SAFETY BULLETIN No. SD-1/008a

Concerning: All SD-1 airplanes up to SN 135

Concurrent Documents: Update of SD1-60-500 and SD1-65-500 drawings

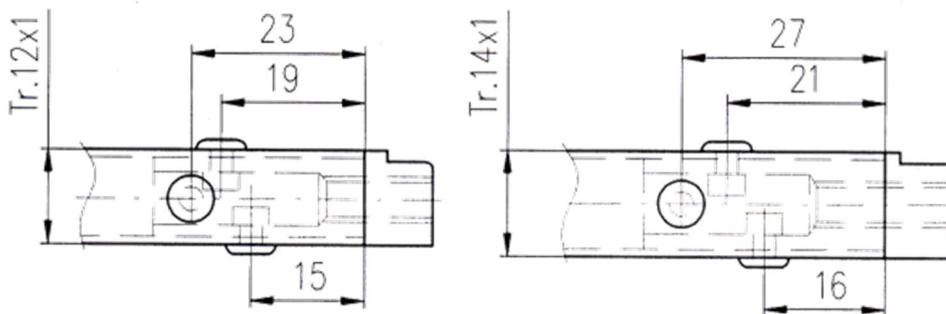
Reason: There were found loosen rod end riveting joints on some airplanes especially in the flaperon controls linkage. There is danger of rivets sheer during continuing operation. This problem is caused by wide production tolerance of aluminium alloy tube ID used in the controls. There are airplanes in the service with TT over 800 hours without any findings.

1. Remove seat from the place
2. Remove fuselage side covers
3. Using sufficient light source check possible movement between tube/rod end/rivets by pulling joint as shown on the bellow picture

1. Remove rod end bearing from the rod end
2. Drill out rivets and pull end out of the tube
3. Wash rod end and tube contact surfaces with acetone and let dry
4. Apply epoxy glue on both surfaces and put end to the tube in the same position as before disassembly.
5. Use either AVDEL 1031 3206 rivets or 1051 3206 for re-riveting.
6. In case that you have used the 1031 (aluminium) rivets add 3rd rivet after cure in accordance to bellow drawing.

7. Reinstall rod end bearing on the rod after cure. Reinstall affected rod and reset controls for proper deflections.
